1429 ECK ROAD OUTDOOR STORAGE
MAJOR PLAN 2022-109
ATTACHMENTS

TO: PLANNING COMMISSION
FROM: GREGG R. ADAMS, PLANNER
SUBJECT: 1429 ECK ROAD OUTDOOR STORAGE
 MAJOR PLAN 2022-109
REQUEST FOR PRELIMINARY/FINAL PLAN REVIEW
DATE: JUNE 9, 2023
COPIES: BOARD OF COMMISSIONERS, T. PETRUCCI, D. MANHARDT, L. HARRIER,
 L. PERIERA ESQ, A. TALLARIDA, S. PIDCOCK, APPLICANT, SUB. FILE 2022-
 109

SUBJECT: South Whitehall Township
1429 Eck Road Outdoor Storage
Major Plan #2022-109
Preliminary/Final Plan Review

PRELIMINARY/FINAL RECORD PLAN

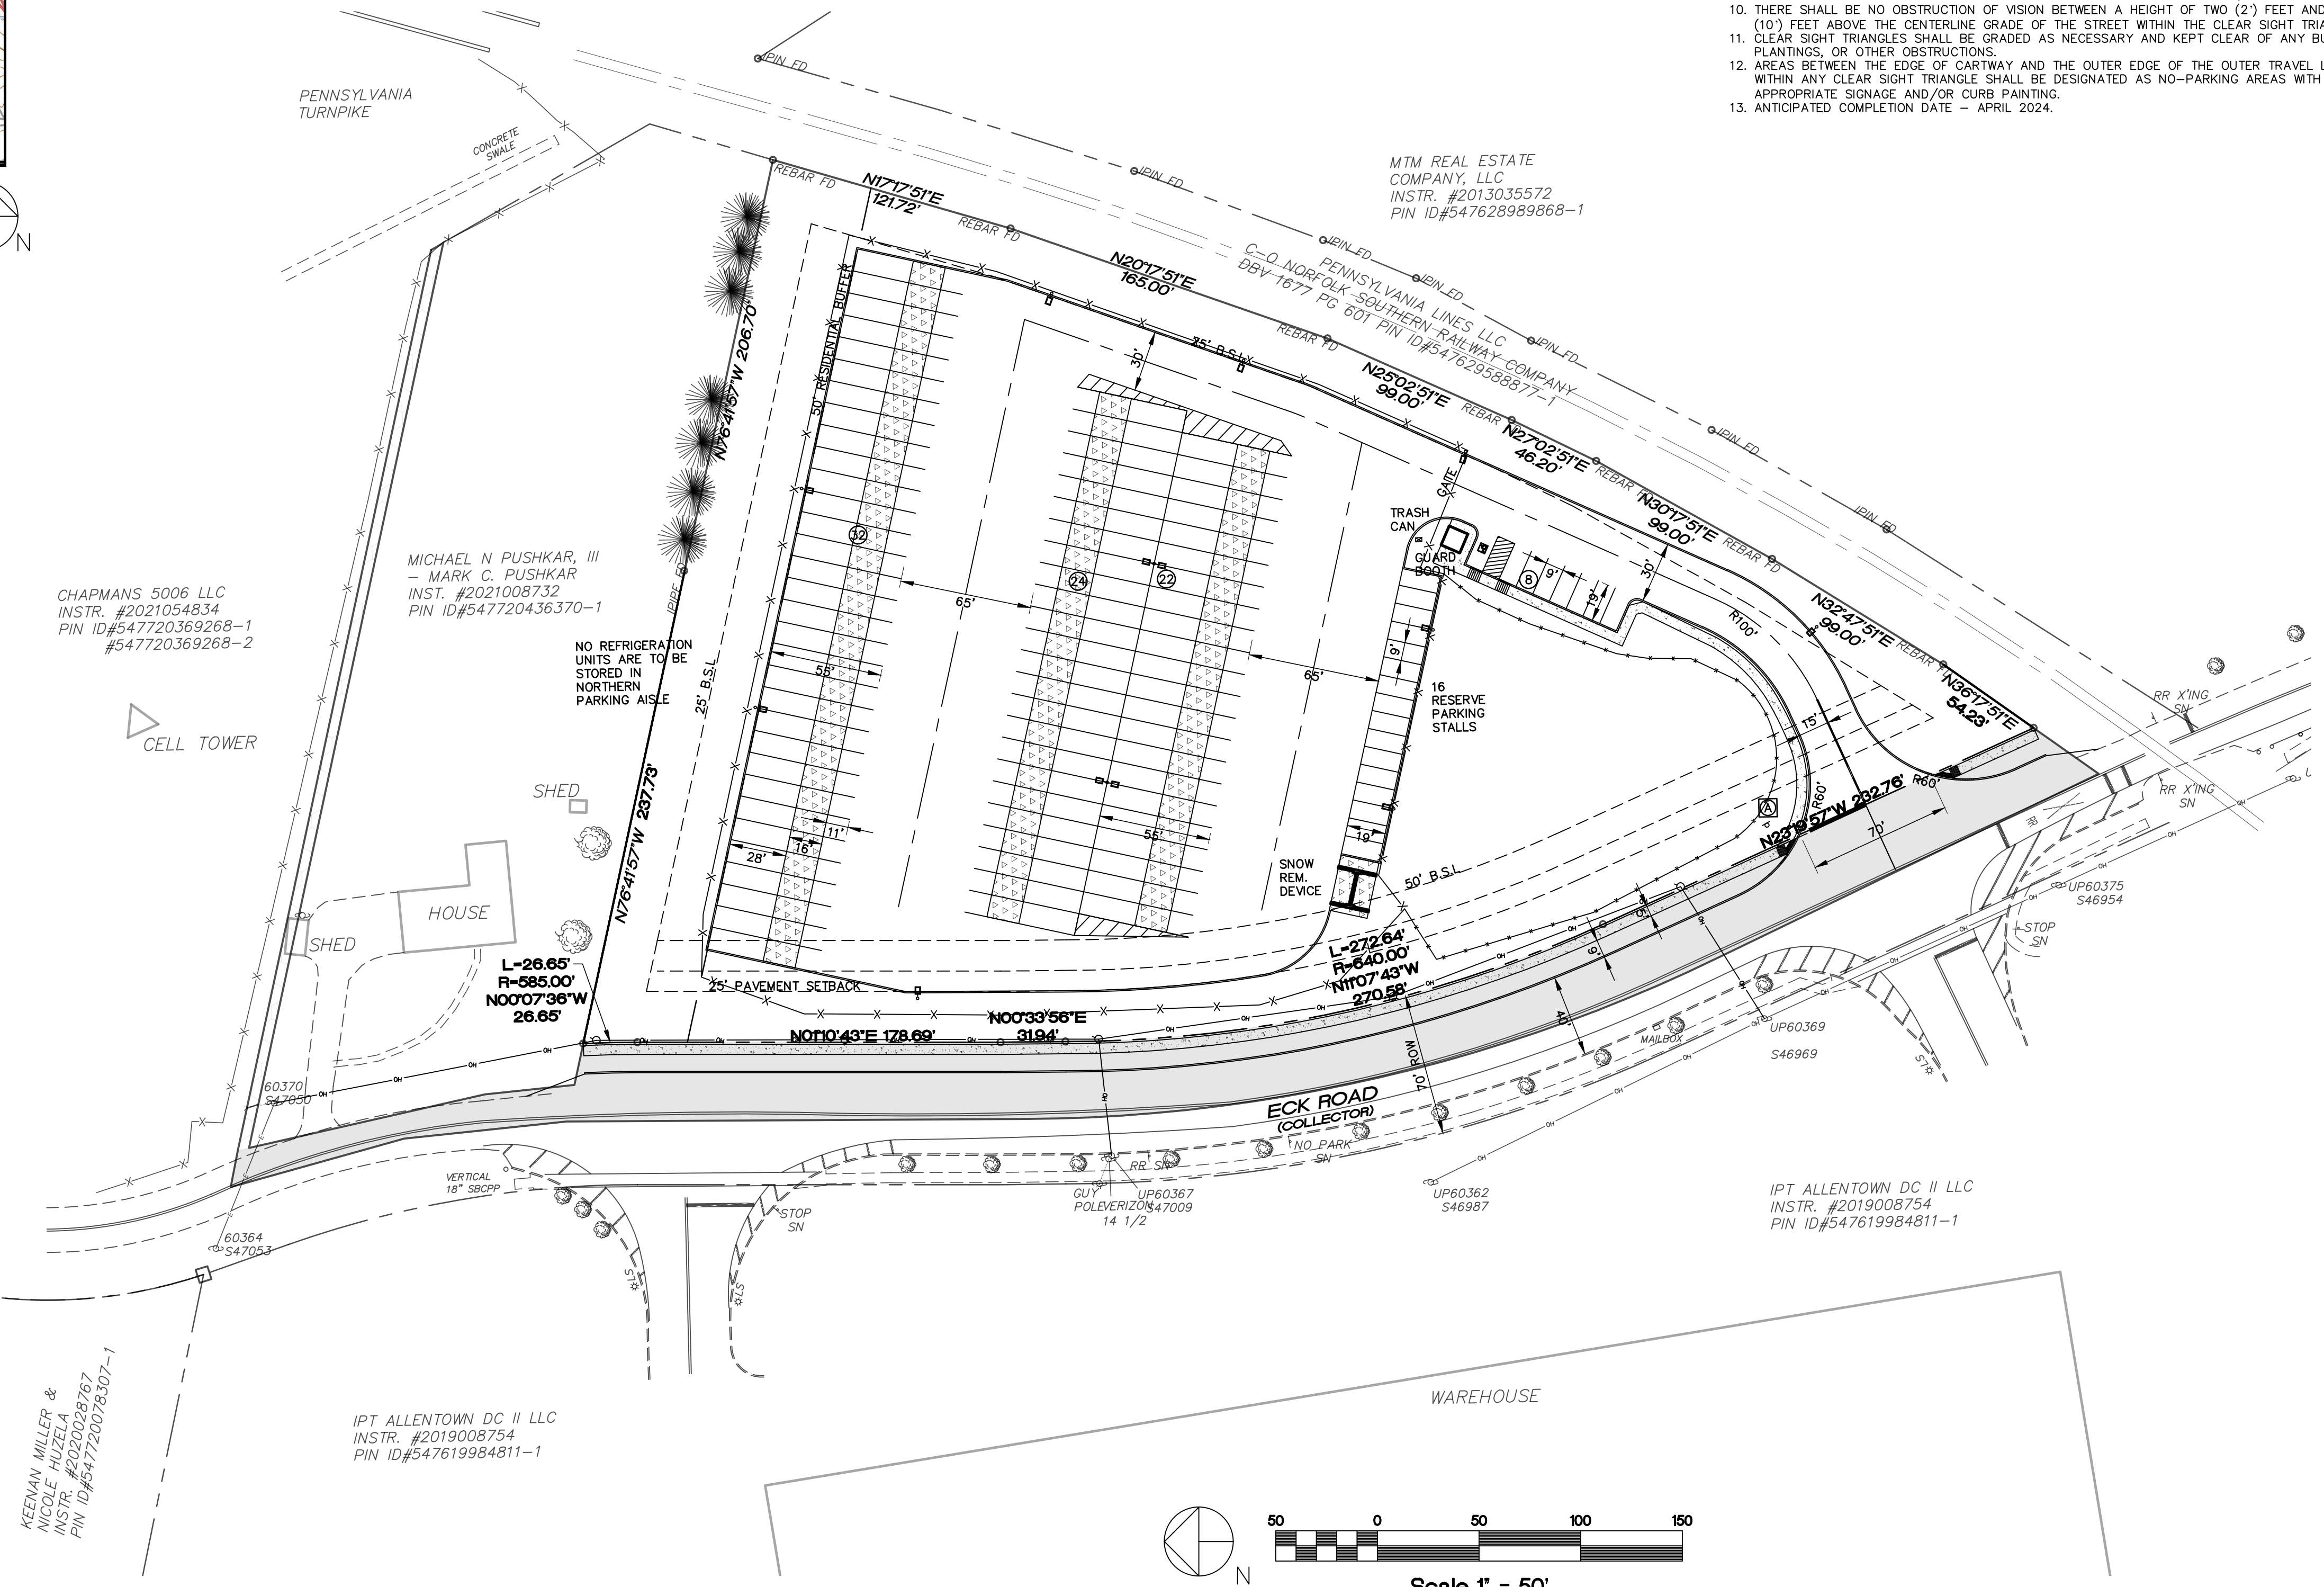
- b. Clearly show the proposed pavement widening area of Eck Road on the Record Plan including showing the limits of milling and overlay. Provide a profile, applicable cross sections, and pavement tie-in details as necessary, SALDO §312-12(b)(31) and §312-12(b)(32); and

2. We note the following survey related comments:
 - a. Clearly define with metes and bounds the “Right-of-way to be Dedicated” (0.711 acres) and the “Area to be Conveyed” (0.053 acres) on the Record Plan, SALDO §312-12(b)(14);

- b. Provide closure reports for the Property Boundary, the “Right-of-way to be Dedicated”, and the “Area to be Conveyed”, SALDO §312-12(b)(14), §312-12(b)(25), §312-12(b)(26), and §312-14(b)(3);

- c. Clarify which property owner will receive the “Area to be conveyed”, SALDO §312-14(b)(3). If applicable, Owners’ Statements should be provided for this property owner;

- d. Check/revise the property information for the Miller/Huzela property, SALDO §312-12(b)(8)(H) and §312-12(b)(17);
 - e. Identify the intent of the setback line measured 35 feet from the Eck Road proposed right-of-way, SALDO §312-12(b)(29); and

- f. Expand the horizontal curve information to be consistent with the requirements in SALDO §312-14(b)(4).
3. The following are comments concerning accessibility on the land development site plans. The review is based on Chapter 11, Appendix E and related accessibility provisions of the 2021 International Building Code (IBC) adopted by the Pennsylvania Construction Code Act 45 as amended (PAUCC), Accessible and Usable Buildings ICC A117.1 2017 (ICC A117.1) referenced in the IBC, and the Pennsylvania Department of Transportation Publication RC-67M (PENNDOT RC-67M):

PRELIMINARY/FINAL
GRADING + UTILITY PLAN

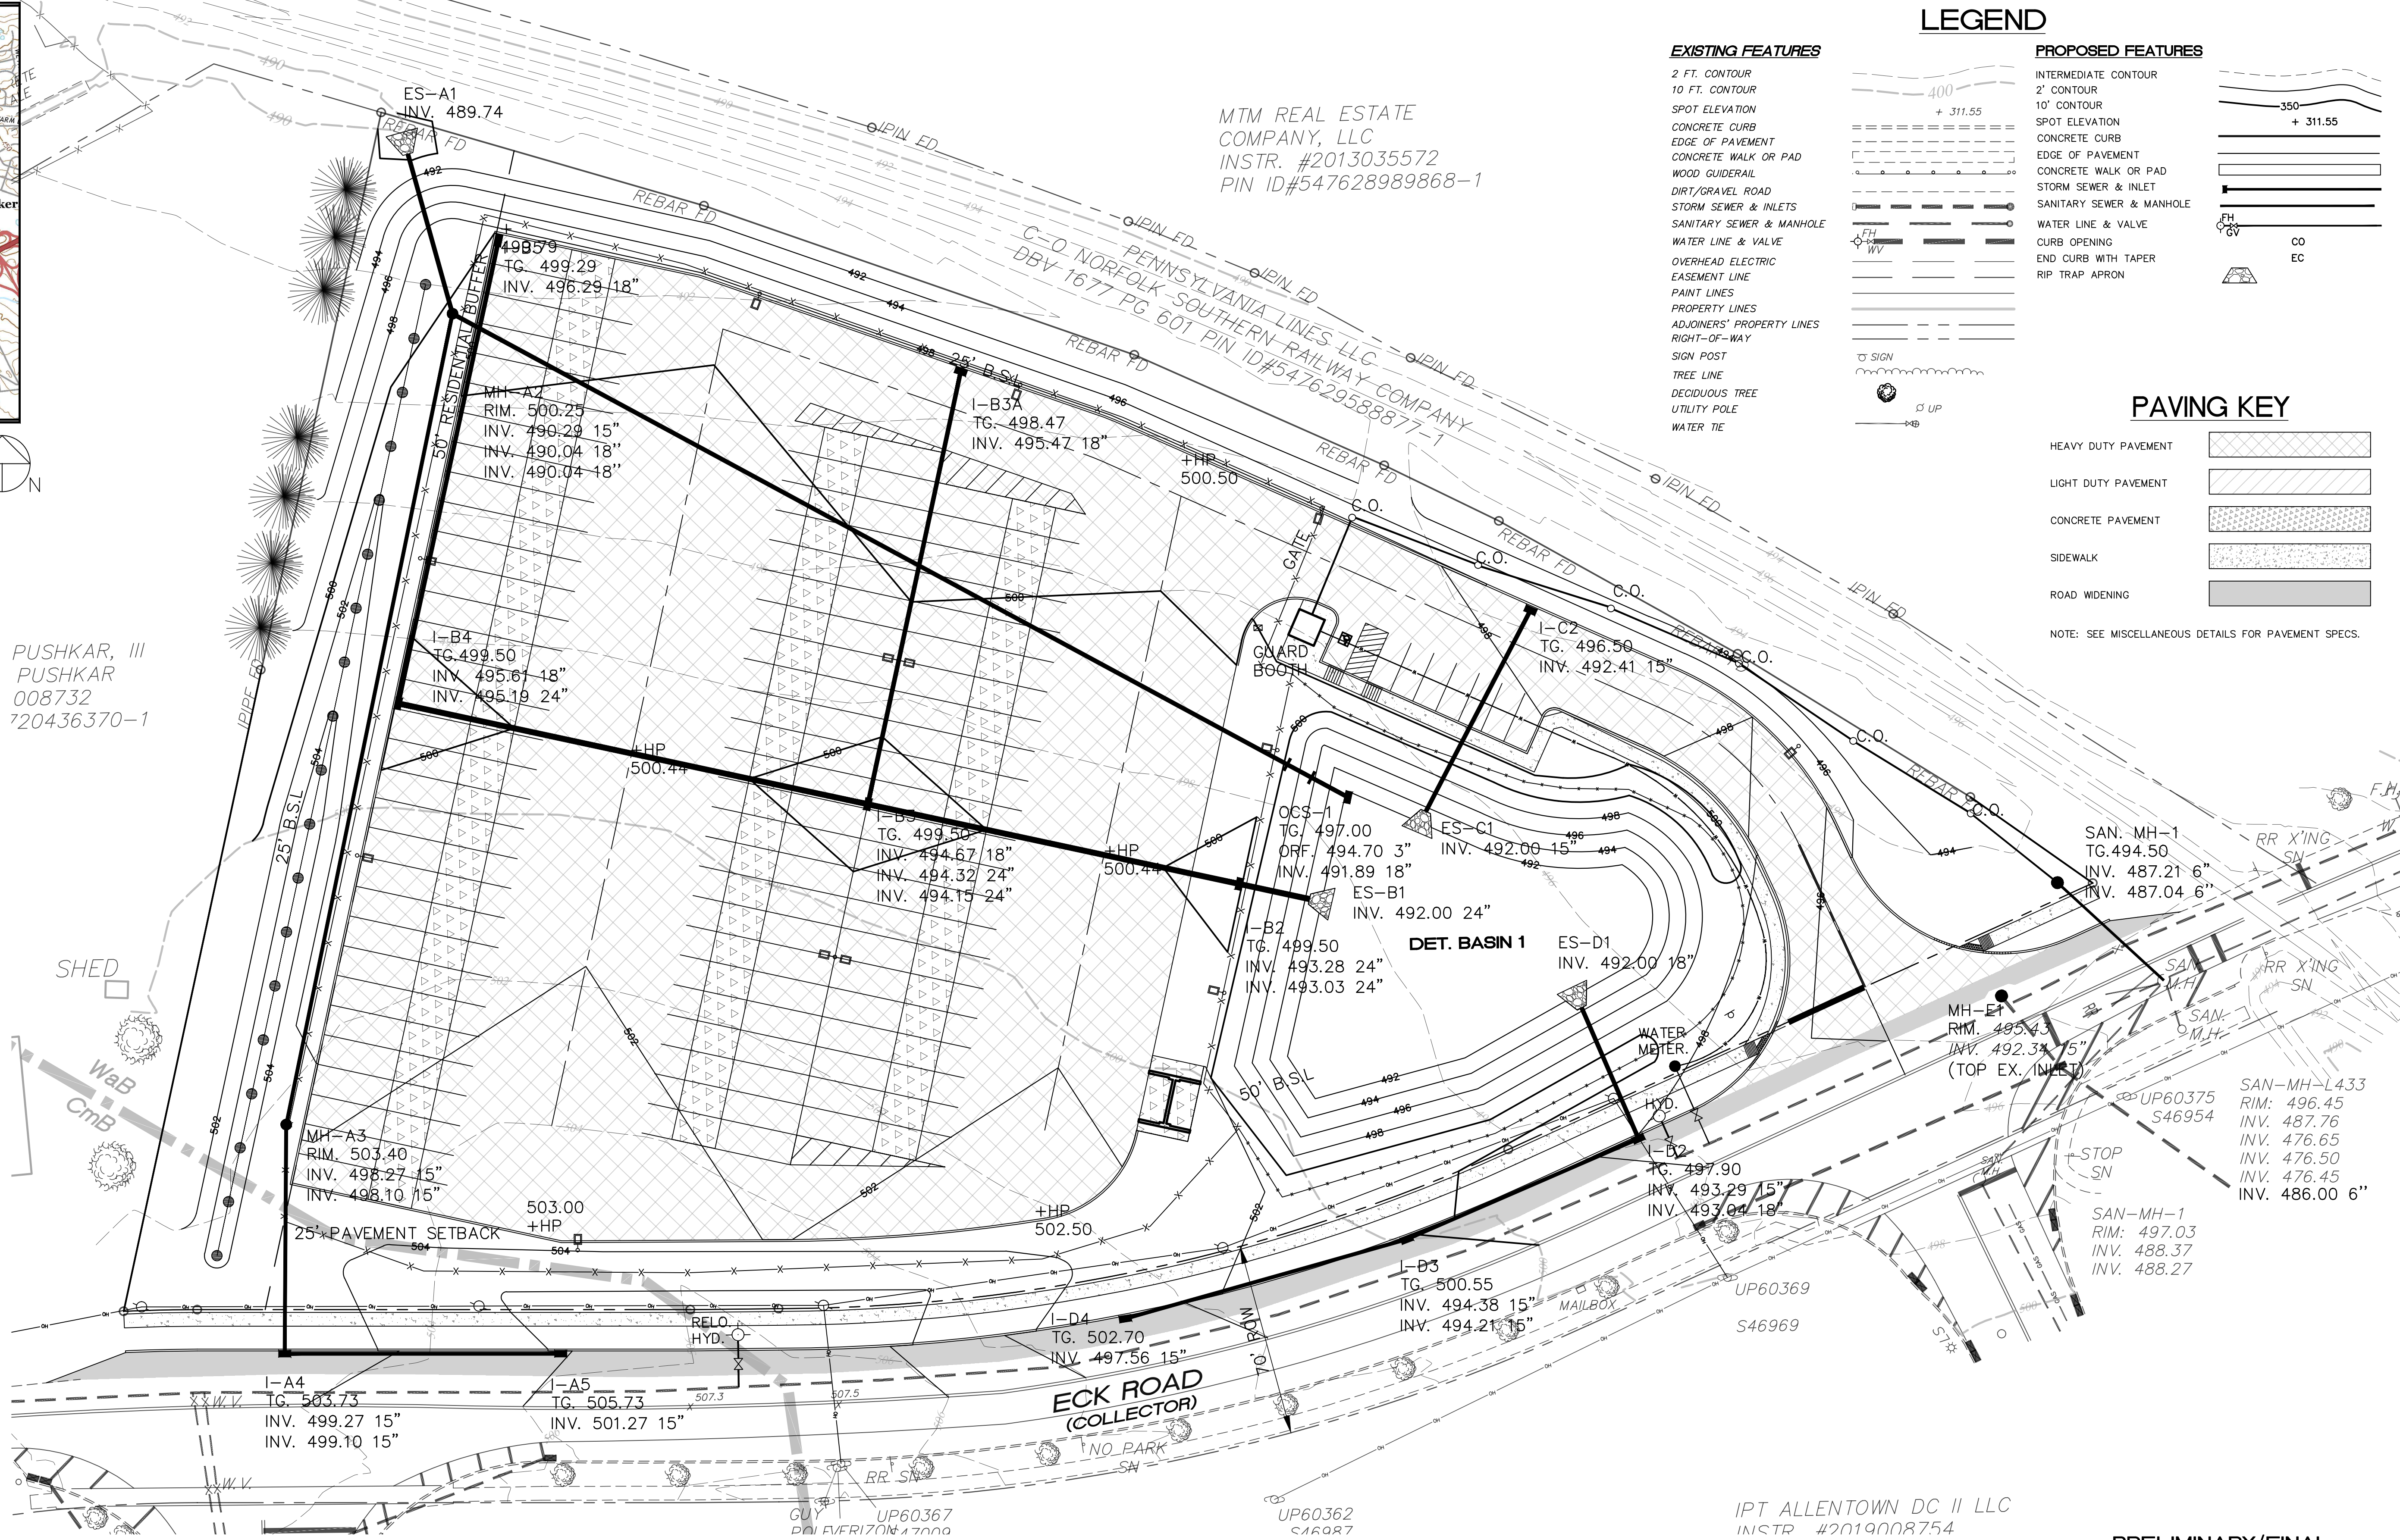
- a. The slopes for the landing near the accessible space should not exceed the maximum allowable slope of 2 percent required by ICC §405.7.1. Check/revise the spot elevations and grading as necessary;

5. The pipes from ES-A1 to OCS 1 should be checked and revised as the capacity is exceeded, SALDO §312-39(b);
6. The downstream HGL for the storm sewer pipes entering the basin should be revised to begin at the 100-year WSEL of the basin, SALDO §312-39(b)(6);
